**Response to Request for Additional Information Regarding ANP-10286P,
“U.S. EPR Rod Ejection Accident Methodology Topical Report”**

**Figure 1-1—Fuel Assembly Layout, Cycle 1, Batch A1
 2.25 wt% U-235, No Gd**

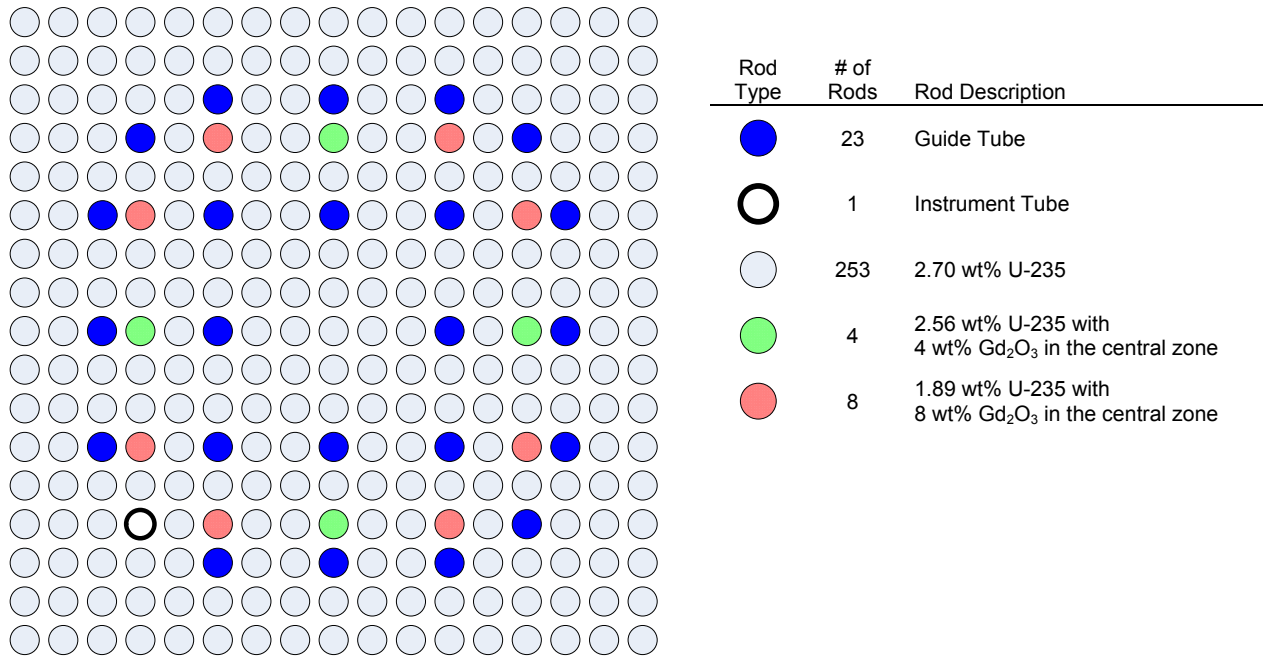
- RAI-1.** *Please provide the following data that was used in the development of the cross sections in the Rod Ejection Accident (RIA) analyses:*
- a. axial and radial enrichments,*
 - b. poison loading,*
 - c. pellet densities,*
 - d. composition and dimensions of cladding materials, control rods, guide tubes, etc.*

The fuel assembly layouts, including radial and axial U^{235} enrichment values and Gd enrichment, for the fuel types in Cycle 1 are shown in Figure 1-1 through Figure 1-7. The same information for the fuel assemblies in the equilibrium cycle are shown in Figure 1-8 through Figure 1-17. These figures are for Cycle 1 and the equilibrium cycle, respectively.
